LINCOLN/LANCASTER COUNTY PLANNING STAFF REPORT

for January 7, 2004 PLANNING COMMISSION MEETING

P.A.S.: Waiver #03014

PROPOSAL: Waive the following requirements associated with Spilkers 4th Addition Final Plat #03014:

SITE PLAN
SCALE: 1" = 60'-0"

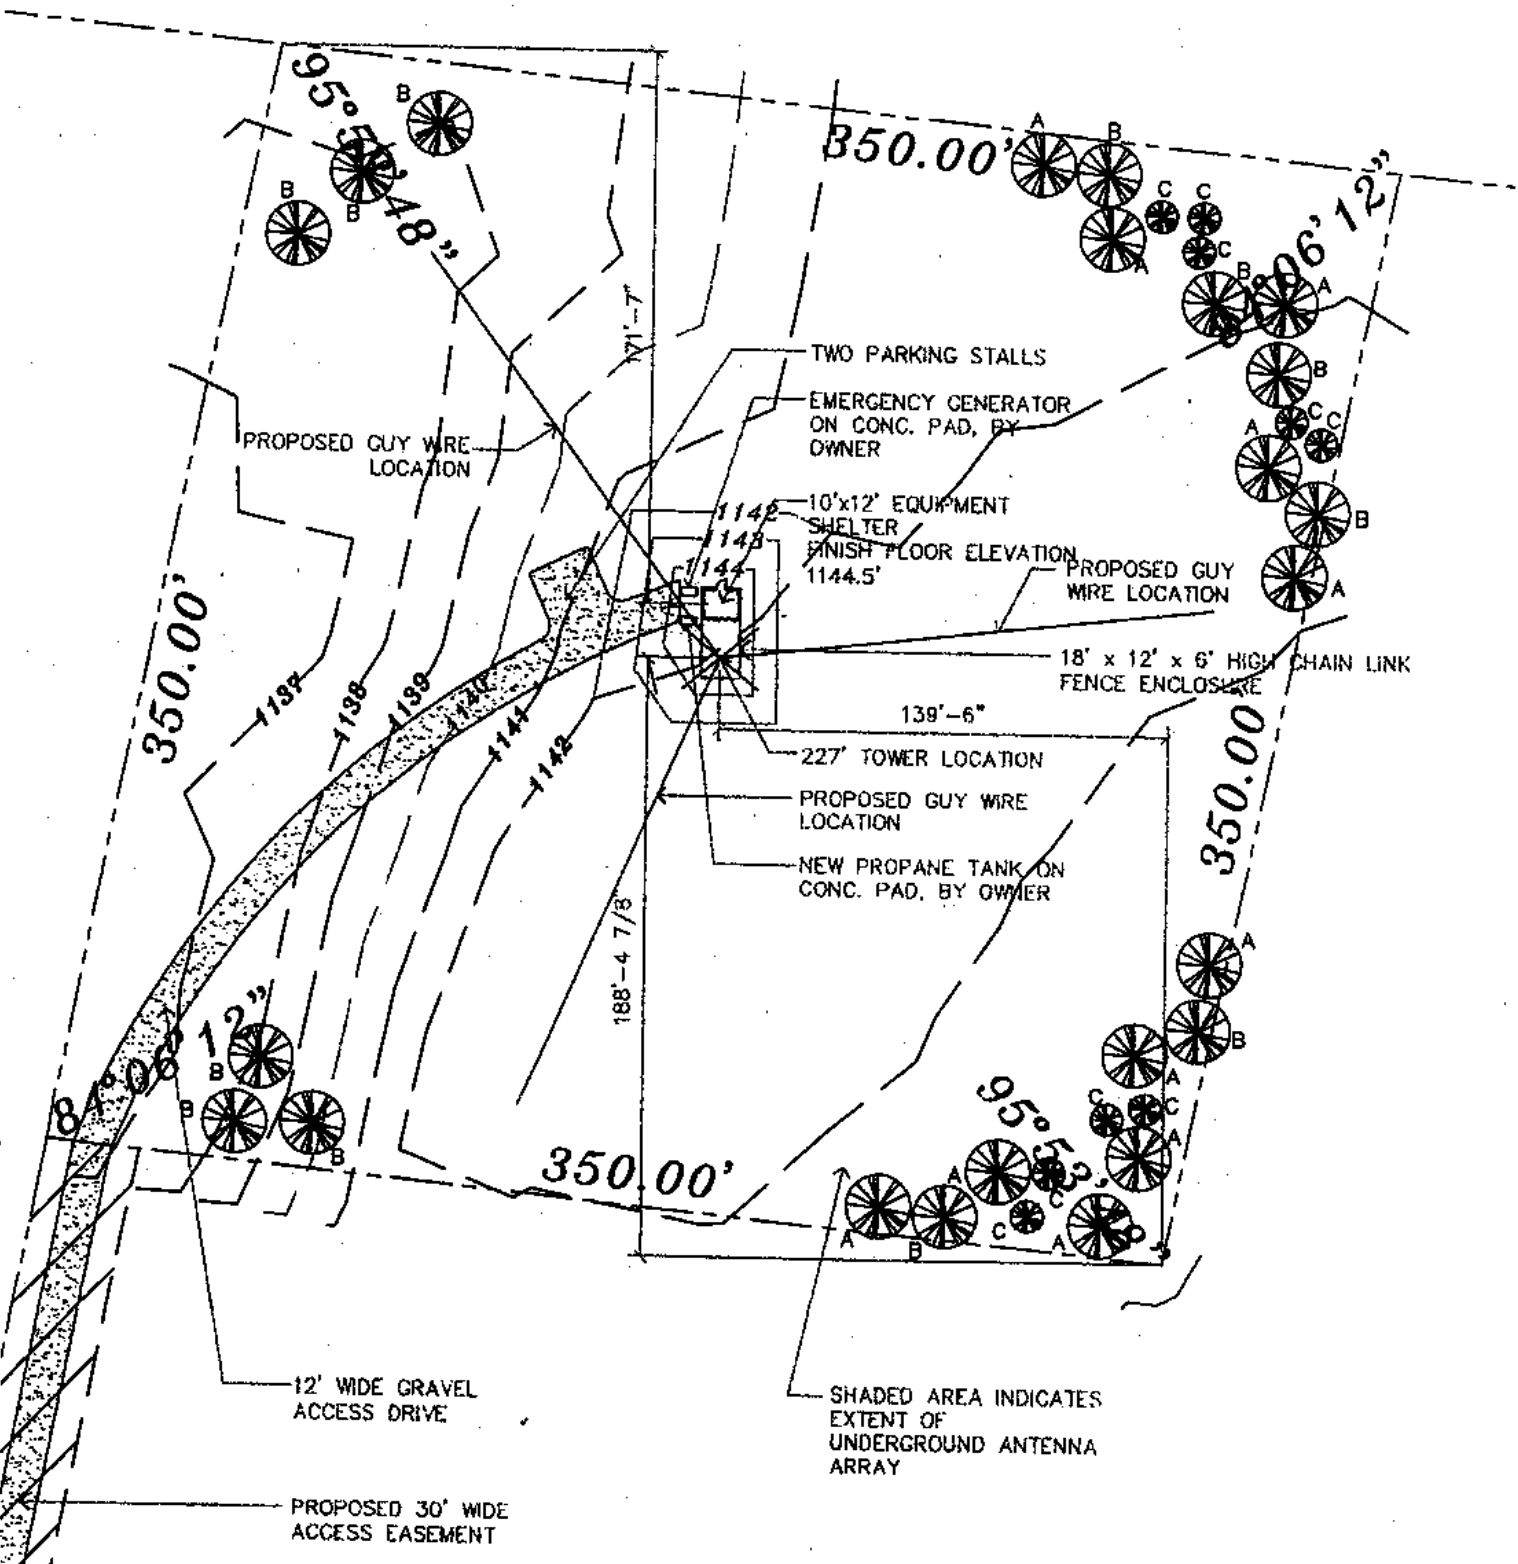
2. This application is associated with Spilker 4th Addition Final Plat #03044.
3. The proposed final plat shows two lots. One lot is proposed for the placement of a broadcast tower.

6. The proposed final plat shows Lot 1 as a lot with no access or frontage to a public or private street. The proposed access to Lot 1 is through a private access easement. Planning Department does not object to this waiver as long as the applicant signs a subdivision agreement tied to the final plat stating that Lot 1 will only be used for a broadcast tower and Lot 2 is created as an Outlot.

1. Public Works objects to the waivers requested especially if Lot 2 is shown as a buildable lot. It is not appropriate to plat Lot 2 as a buildable lot without an approved preliminary plat showing appropriate improvements meeting design standards. There is no abutting pavement except the right angle 90° intersection frontage of Gladstone and 33rd. A driveway for an industrial lot is inappropriate. A minimum use driveway providing access to the proposed tower lot can probably be approved. The justification for waivers addresses Lot 1. The letter provides no justification for the Lot 2 requirements.

2. Engineering Services suggests that rather than waive subdivision improvement requirements, both lots be platted as outlots with provisions made to allow the tower to be constructed on the outlot shown as Lot 1. Neither lot has the improvements required for subdivision or the improvements necessary for the uses allowed per the zoning code.

could be waived at this time as long as Lot 2 is changed to an Outlot on the final plat of Spilkers 4th Addition, since no development may occur on an Outlot.
